ROBERT STEVENS ASSOCIATES ARCHITECTURE & PLANNING 200 N. 25th St., Suite 1111 Fresno, CA 93703 (559) 232-1111 www.rsassoc.com	C4854 CDPI, #443 A-12 of sheets
---	--	--

Selland Arena - Auditorium
 700 M Street, Fresno

Selland Arena (SA)

ADDITIONS & REMODELED
 NORTH END CROSS AISLE LEVEL (109'-0")
 SCALE: 1/8" = 1'-0"

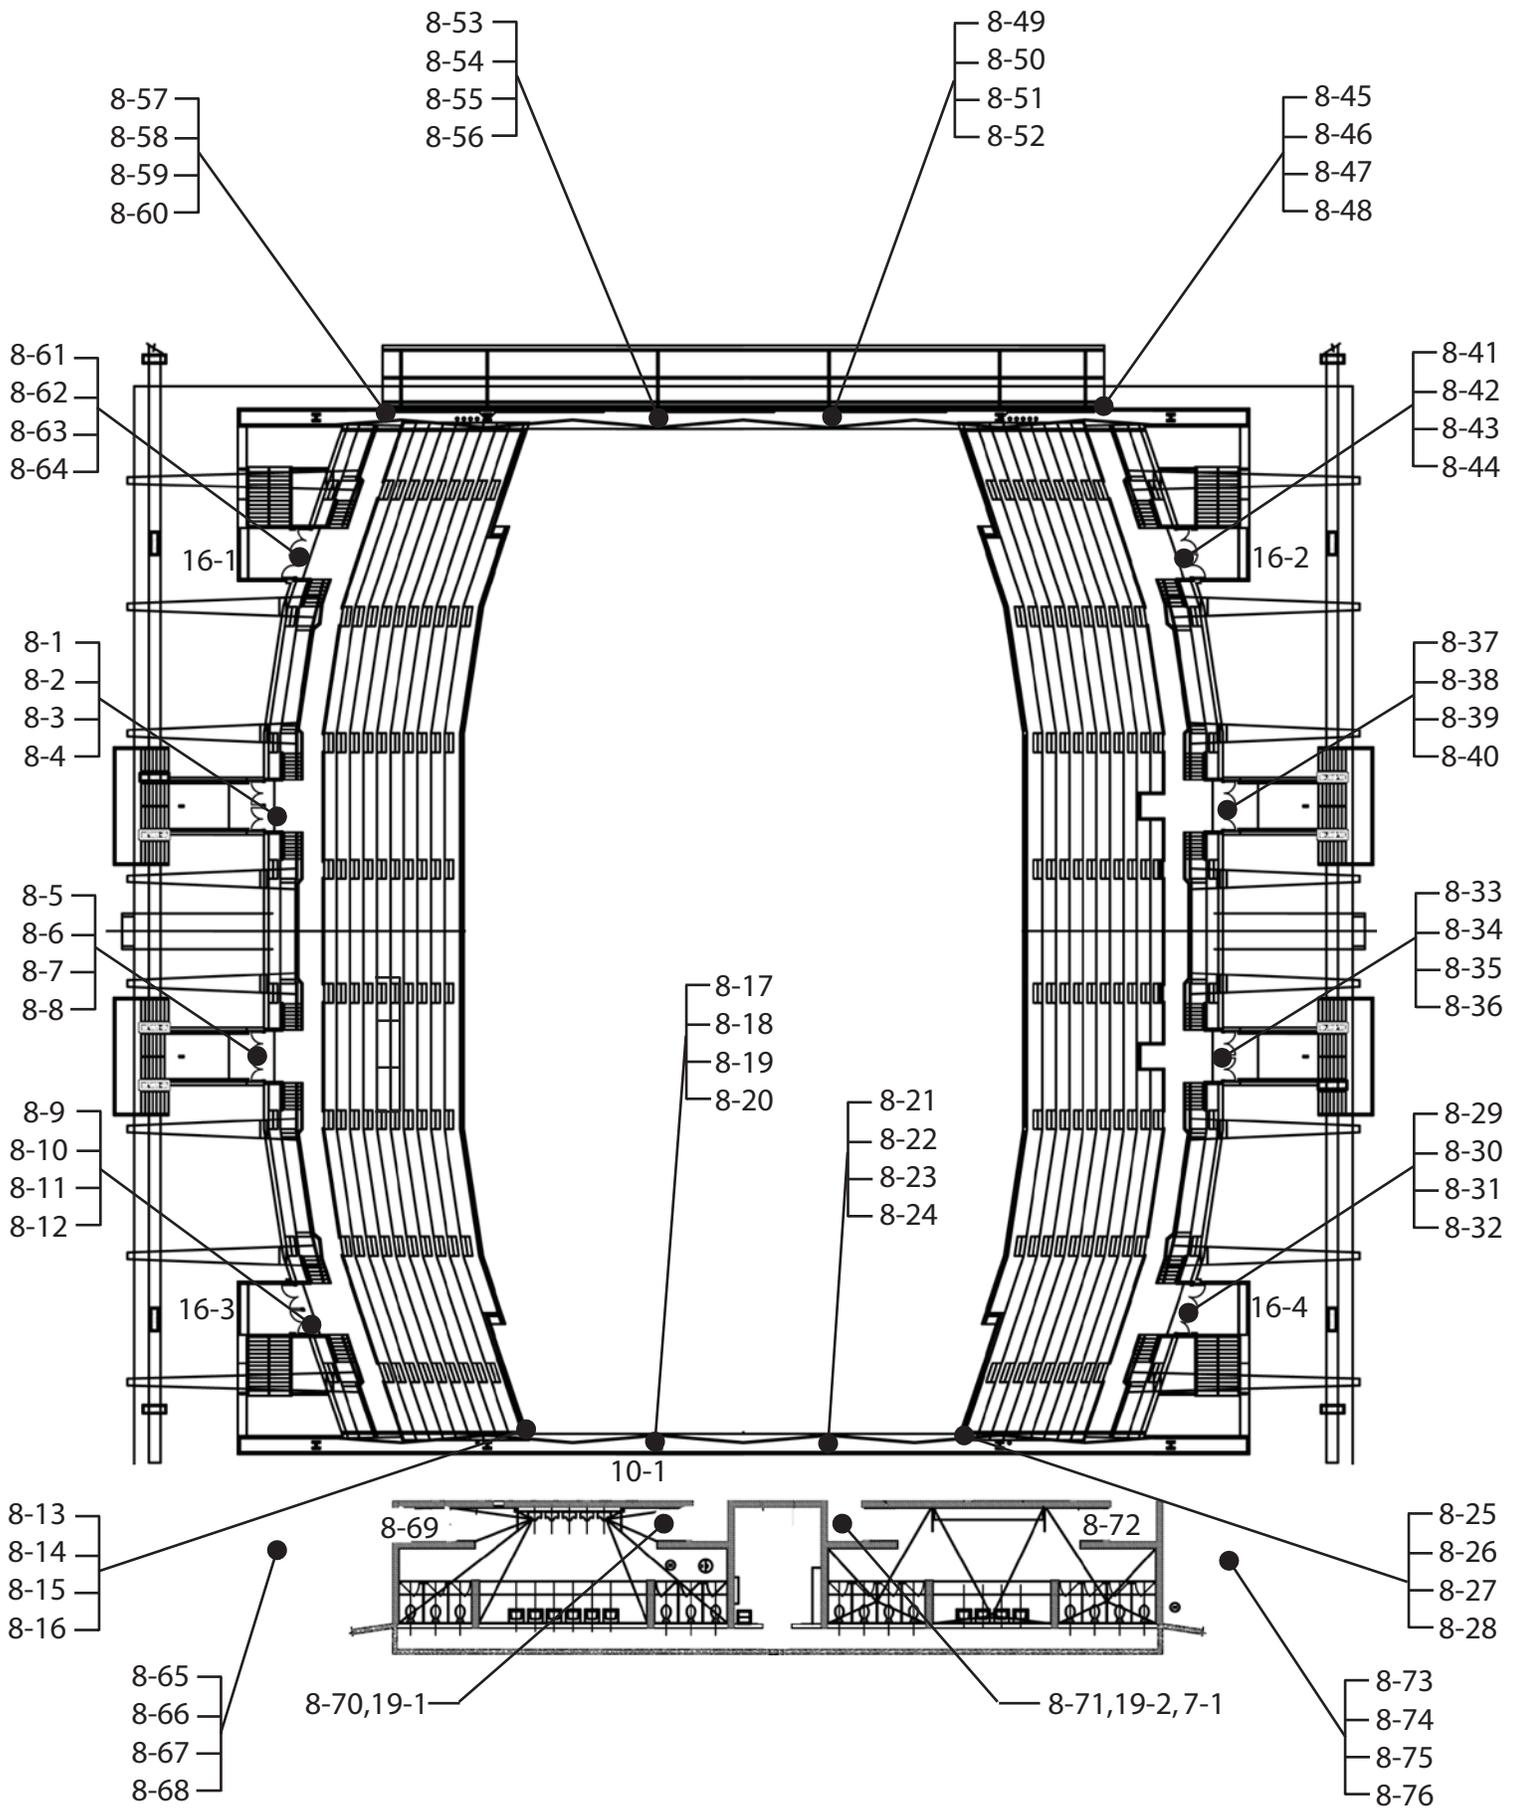
6 - 1 Stairway Priority:2

Install tread striping \$3,840

Notes: Indicator stripes are faded. There are 8 risers per set. There are 32 sets with the same issue.

Replace stairs \$0

Notes: Tread width is 10" (11" min). Risers are 7-1/2" (7" max) high. There are 8 risers per set. There are 32 sets of the same staircase with the same issue.

Install or modify handrails \$140,800

Notes: Top extensions are only provided on one side. Handrail diameter is 2" (1-1/4" to 1-1/2"). Handrails are 2-1/4" (1-1/2") from the wall. There is a total of 32 sets of handrails with the same issues.

6 - 2 Stairway Priority:2

Replace stairs \$0

Notes: Tread width is 10" (11" min). Risers are 8" (4" to 7") high. There is a total of 16 risers per set. There are 4 sets of stairs with the same issues.

Install or modify handrails \$30,400

Notes: The outer handrails are not continuous. Extensions at the top are not provided. Handrail top surface is mounted 31" (34" to 38") AFF. Handrail diameter is 2" (1-1/4" to 1-1/2"). Handrail is 2" (1-1/2") from the wall. 4 sets of stairs with same issue.

Floor AUD		
6 - 3	Stairway	Priority:2
Install tread striping		\$1,440
Notes: Indicator stripes are faded. There are 12 risers per set. There are 8 sets with the same issue.		
State: 1133B.4.4		
Federal: -		
Replace stairs		\$0
Notes: Width of stair is 35" (44" min). Tread width is 10-1/2" (11" min). There are 12 risers per set. There are 8 sets of the same staircase with the same issue.		
State: 1007.3, 1009.1, 1133B.4.5.3		
Federal: 4.9.2		
Install or modify handrails		\$48,000
Notes: Handrail with continuous gripping surface is only provided on one side. Top and bottom extensions are only provided on one side. Handrail diameter is 2" (1-1/4" to 1-1/2"). There is a total of 8 sets of handrails with the same issues.		
State: 1133B.4.1.1, 1133B.4.2.2, 1133B.4.2.5, 1133B.4.2.6		
Federal: 4.26.2, 4.9.4, 4.9.4 #2, 4.9.4 #3		
6 - 4	Stairway	Priority:2
Install tread striping		\$240
Notes: Indicator stripes are not contrasting. There are 16 risers.

Floor AUD		
6 - 5	Stairway	Priority:2
Install tread striping		\$240
Notes: Indicator stripes are not contrasting. There are 16 risers.		
State: 1127B.4, 1133B.4.4		
Federal: -		
Repair stair nosings		\$6,000
Notes: Risers are open. There are 16 risers.		
State: 1133B.4.5.3		
Federal: 4.9.2		
Install or modify handrails		\$7,600
Notes: Extensions at the top and bottom are not provided. Handrail top surface is mounted 32" (34" to 38") AFF. Handrail diameter is 2" (1-1/4" to 1-1/2").		
State: 1133B.4.2.1, 1133B.4.2.2, 1133B.4.2.6		
Federal: 4.26.2, 4.9.4 #2, 4.9.4 #5		
6 - 6	Stairway	Priority:2
Install tread striping		\$240
Notes: Indicator stripes are not contrasting. There are 16 risers.		
State: 1127B.4, 1133B.4.4		
Federal: -		
Repair stair nosings		\$6,000
Notes: Risers are open. There are 16 risers.		
State: 1133B.4.5.3		
Federal: 4.9.2		
Install or modify handrails		\$7,600
Notes: Extensions at the top and bottom are not provided. Handrail top surface is mounted 31" (34" to 38") AFF. Handrail diameter is 2" (1-1/4" to 1-1/2").

Seland Arena - West Wing - Loge Floor
700 M Street, Fresno

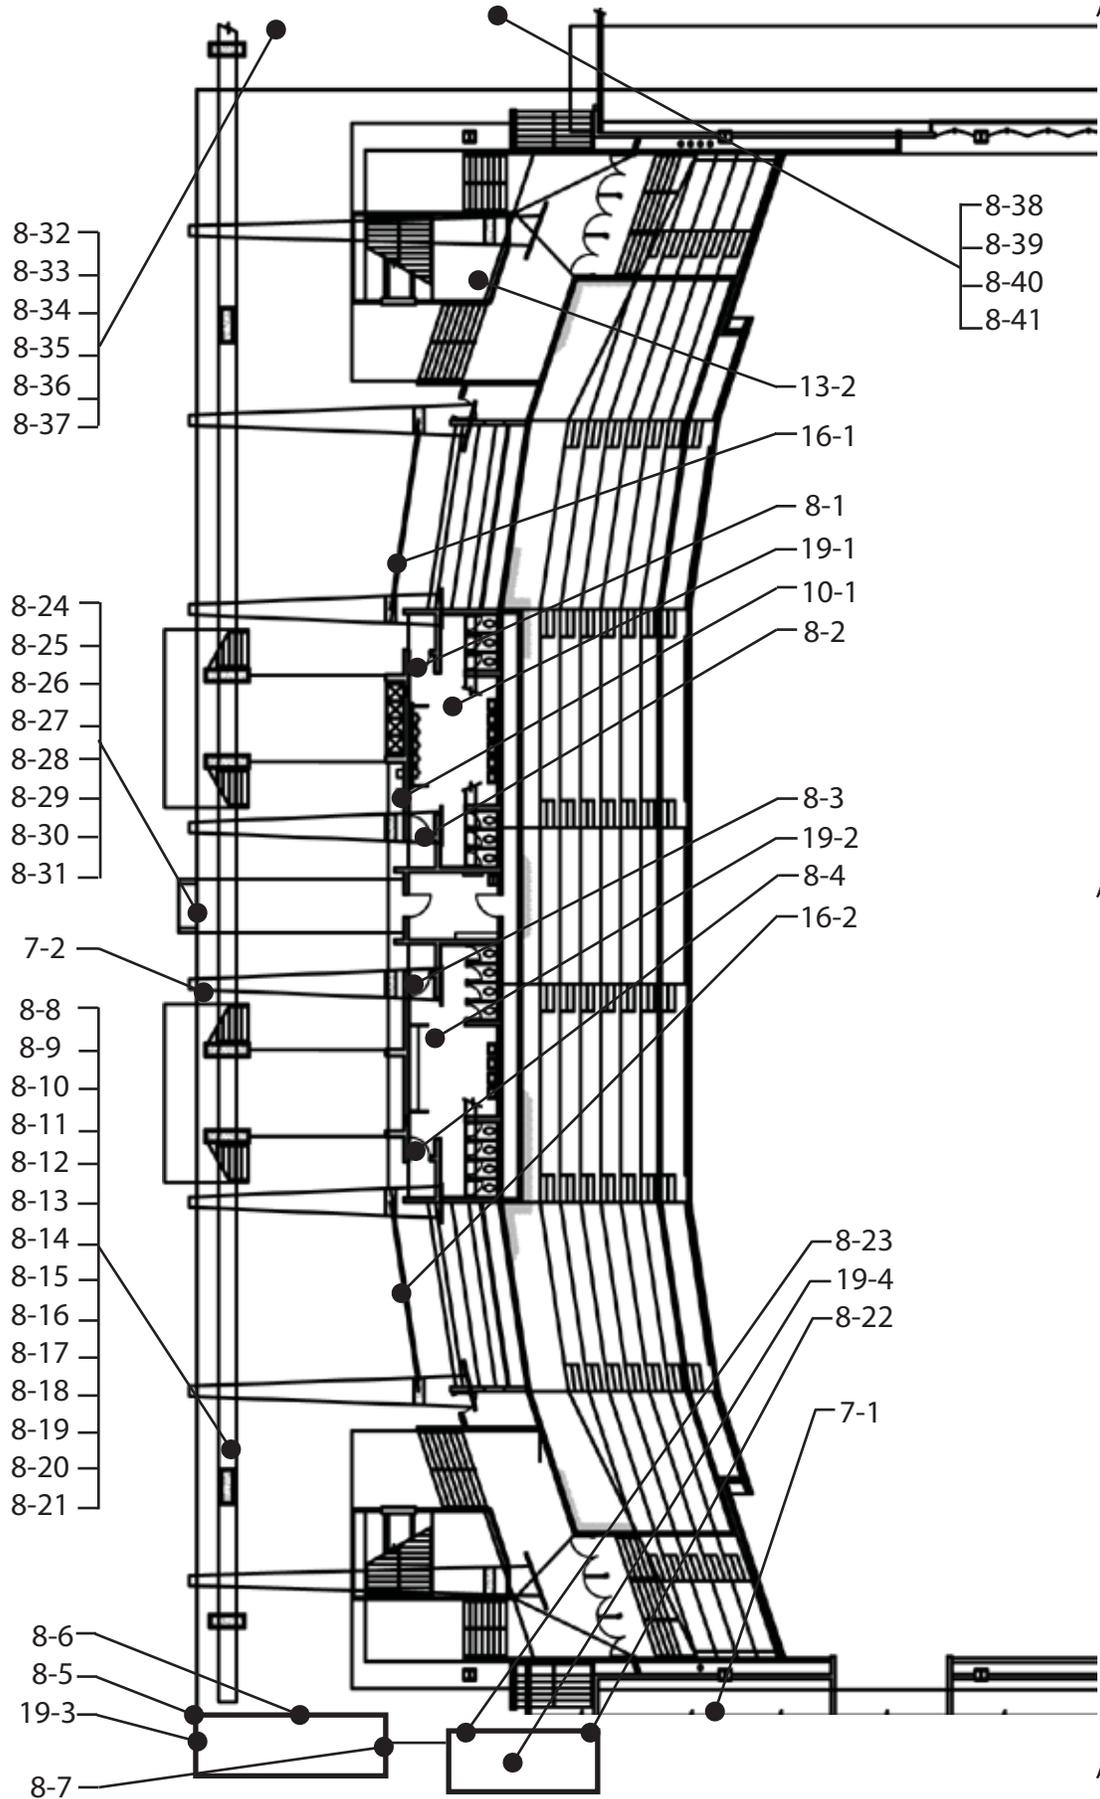
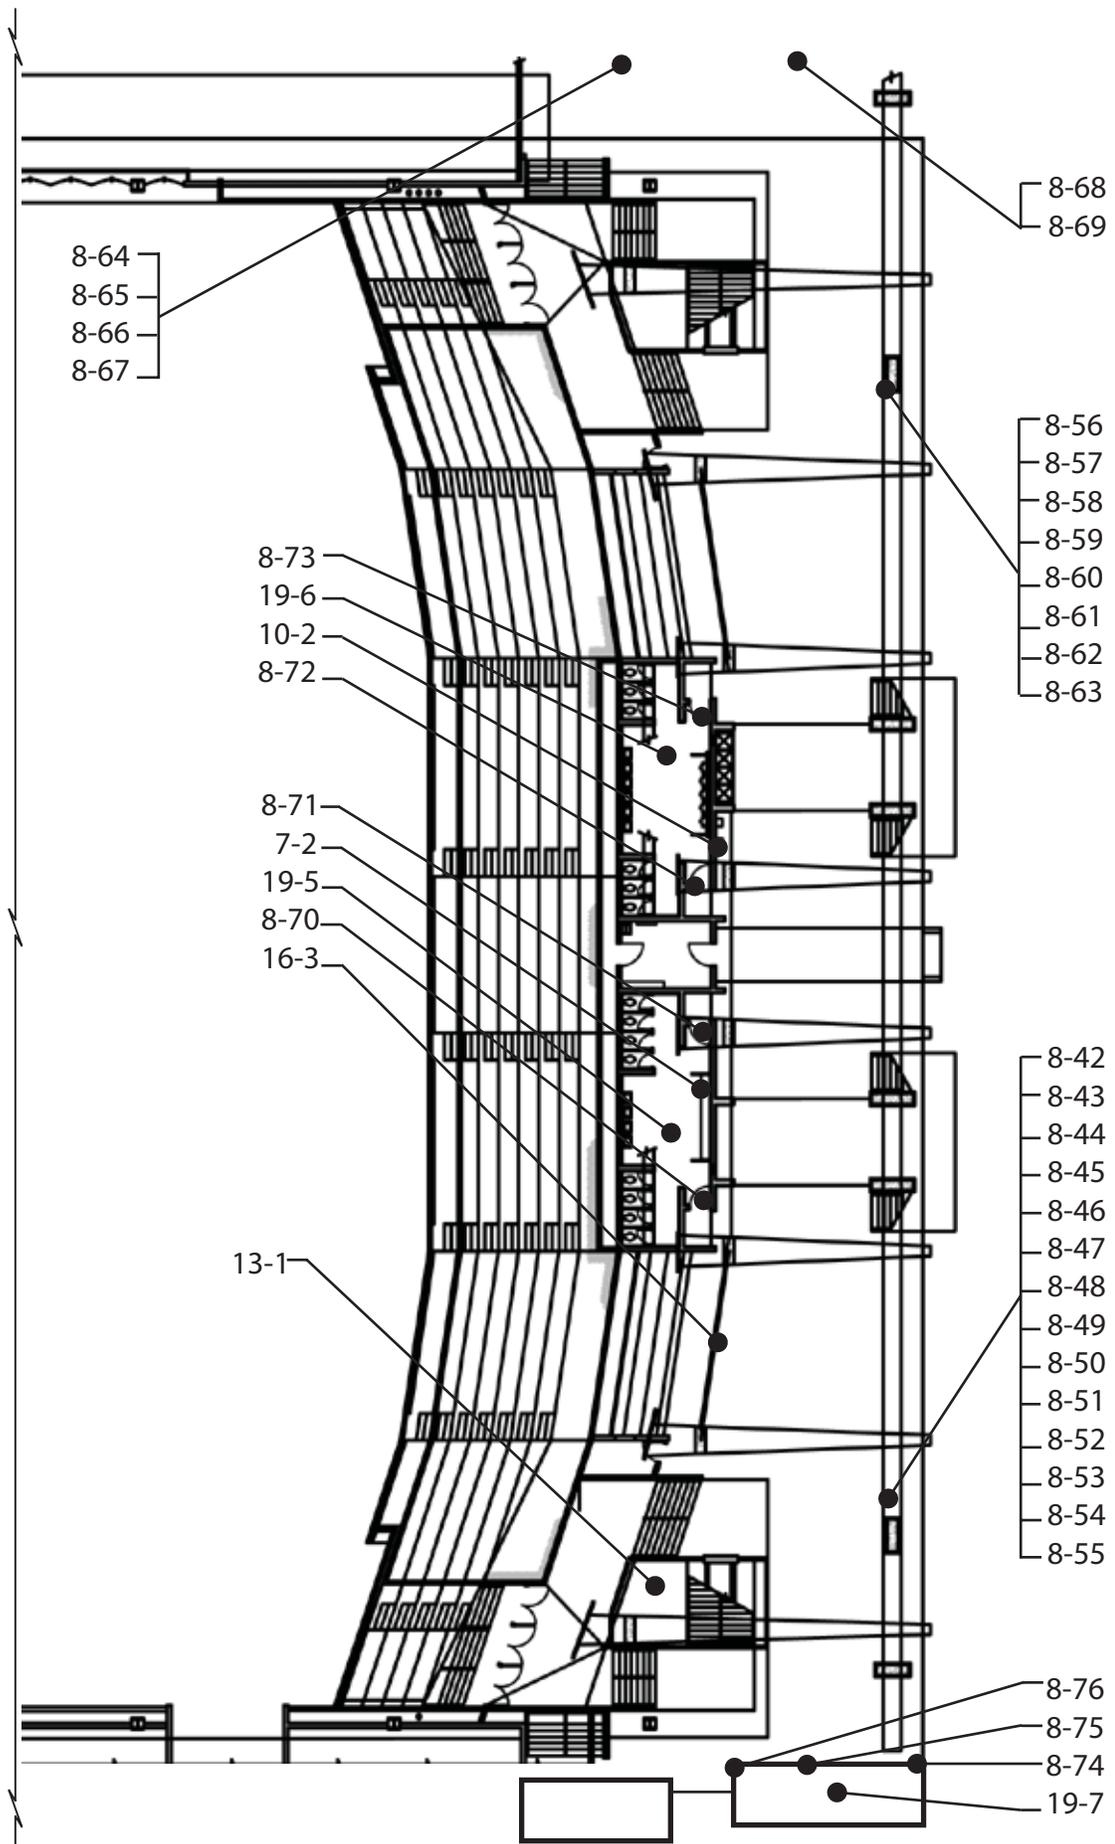
Floor Loge		
7 - 1	Hazard	Priority:2
Remove overhanging or protruding objects		\$100
Notes: Fire extinguisher protrudes 8-1/2" (4" max) and is 48" (not between 27" to 80") above the finished floor.		
State: 1133B.8.6.1		
Federal: 4.4.1		
7 - 2	Hazard	Priority:2
Remove overhanging or protruding objects		\$100
Notes: Sanitary napkin dispenser protrudes 6-1/2" (4" max) and is 45-1/4" (not between 27" to 80") above the finished floor.		
State: 1133B.8.6.1		
Federal: 4.4.1		
8 - 1	Door/Gate	Priority:2
Adjust door closer		\$100
Notes: Operating effort is 12 lbs (5 lbs max).		
State: 1133B.2.5		
Federal: 4.13.11		
Provide additional strike edge clearance		\$3,000
Notes: Strike-edge clearance on swing-side is 11-1/2" (18" min).		
State: 1133B.2.4.3		
Federal: 4.13.6		
Provide additional strike edge clearance		\$3,000
Notes: Strike-edge clearance on push-side is 11-1/2" (12" min).		
State: 1133B.2.4.3		
Federal: 4.13.6

8 - 2	Door/Gate	Priority:2
Adjust door closer		\$100
Notes: Operating effort is 29 lbs (5 lbs max).		
State: 1133B.2.5		
Federal: 4.13.11		
Provide additional strike edge clearance		\$3,000
Notes: Strike-edge clearance on swing-side is 10-1/2" (18" min).		
State: 1133B.2.4.3		
Federal: 4.13.6		
Provide additional strike edge clearance		\$3,000
Notes: Strike-edge clearance on push-side is 10-1/2" (12" min).		
State: 1133B.2.4.3		
Federal: 4.13.6

Floor Loge	
8 - 3	Door/Gate Priority:2
Adjust door closer	\$100
Notes: Operating effort is 16 lbs (5 lbs max).	
State: 1133B.2.5	
Federal: 4.13.11	
Provide additional strike edge clearance	\$3,000
Notes: Strike-edge clearance on swing-side is 10-1/2" (18" min).	
State: 1133B.2.4.3	
Federal: 4.13.6	
Provide additional strike edge clearance	\$3,000
Notes: Strike-edge clearance on push-side is 10-1/2" (12" min).	
State: 1133B.2.4.3	
Federal: 4.13.6	
8 - 4	Door/Gate Priority:2
Adjust door closer	\$100
Notes: Operating effort is 15 lbs (5 lbs max).	
State: 1133B.2.5	
Federal: 4.13.11	
Provide additional strike edge clearance	\$3,000
Notes: Strike-edge clearance on swing-side is 11" (18" min).	
State: 1133B.2.4.3	
Federal: 4.13.6	
Provide additional strike edge clearance	\$3,000
Notes: Strike-edge clearance on push-side is 11" (12" min).	
State: 1133B.2.4.3	
Federal: 4.13.6

Floor Loge	
10 - 1	Priority: 3
Drinking Fountain	\$3,500
Replace or reposition drinking fountain	
Notes: There are two identical drinking fountains. Depth is 12-1/2" (18" min). Bubbler height is 37" (36" max) above the finished floor. Provide "hi-lo" drinking fountain.	
State: 1115B.4.6 #1, 1115B.4.6 #4, 1117B.4.6 #2	
Federal: 4.1.6, 4.15.2, 4.15.5	
10 - 2	Priority: 3
Drinking Fountain	\$3,500
Replace or reposition drinking fountain	
Notes: Depth is 13" (18" min). There are two drinking fountains but they are at the same height. Provide "hi-lo" drinking fountain.	
State: 1115B.4.6 #1, 1117B.4.6 #2	
Federal: 4.1.6, 4.15.5	
Replace or adjust water controls	
Notes: Control requires grasping and twisting.	
State: 1115B.4.6 #4	
Federal: 4.15.4	
Adjust water stream	
Notes: Bubbler directs water flow in a stream that is 1" (4" min) high.	
State: 1115B.4.6 #5	
Federal: 4.15.3

Floor Loge	
13 - 1 Elevator	Priority: 1
Adjust or provide elevator signals and indicators	\$0
Notes: Hallway lanterns are 60" (72" min) above the finished floor.	
State: 1116B.1.13	
Federal: 4.10.4 #1	
Enlarge elevator	\$200,000
Notes: Door width is 34" (36" min).	
State: 1116B.1.4	
Federal: 4.10.9	
Adjust elevator controls and labeling	\$0
Notes: Emergency stop button is not raised.	
State: 1116B.1.8	
Federal: 4.10.12 #3	
Reduce gap between car and hall floors	\$0
Notes: Gap between the car floor and the hall floor is 1-1/2" (1-1/4" max).	
State: 1116B.1.2	
Federal: 4.10.9	
Adjust elevator operation	\$0
Notes: Elevator comes to rest at 1-1/2" (1/2" max) of the floor surface.	
State: 1116B.1.2	
Federal: 4.10.2	
Adjust elevator operation	\$0
Notes: Optical, automatic door opening sensors are not provided. Door remains open for 2 seconds (5 seconds min).	
State: 1116B.1.5, 1116B.1.7	
Federal: 4.10.6	
Adjust or provide elevator signals and indicators	\$0

Floor Loge	
16 - 1	Transaction Counter Priority:2
Provide an accessible counter	\$4,000
Notes: Concession stand counter is 44" (28" to 34" max) above the finished floor.	
State: 1122B.5	
Federal: 4.32.4	
16 - 2	Transaction Counter Priority:2
Provide an accessible counter	\$4,000
Notes: Concession stand counter is 44" (28" to 34" max) above the finished floor.	
State: 1122B.5	
Federal: 4.32.4

Floor Loge	
19 - 1 Multiple User Restroom	Priority:2
Install sign	\$100
Notes: California signage on the door is centered at 62" (60" req) above the finished floor. Raise signage.	
State: 1115B.6	
Federal: 4.30.4	
Install sign	\$250
Notes: Federal required signage is not provided on the latch side of the door. International Symbol of Accessibility is not provided.	
State: 1115B.6, 1117B.5.1 #1, 1117B.5.5 #3, 1117B.5.8.1.2	
Federal: 4.30.4	
Replace or reposition dispensers or mirrors	\$200
Notes: Mirrors are mounted so bottom of reflecting surface are 50" (40" max) above the finished floor.	
State: 1115B.8.1	
Federal: 4.19.6	
Replace or reposition dispensers or mirrors	\$500
Notes: Towel dispenser is 45-1/2" (40" max) and soap dispenser is 40-1/2" (40" max) above the finished floor.	
State: 1115B.8.3	
Federal: 4.23.7	
Modify lavatory/counter clearances	\$1,500
Notes: Clear space beneath the lavatory sink is 27-1/2" (29" min) high.
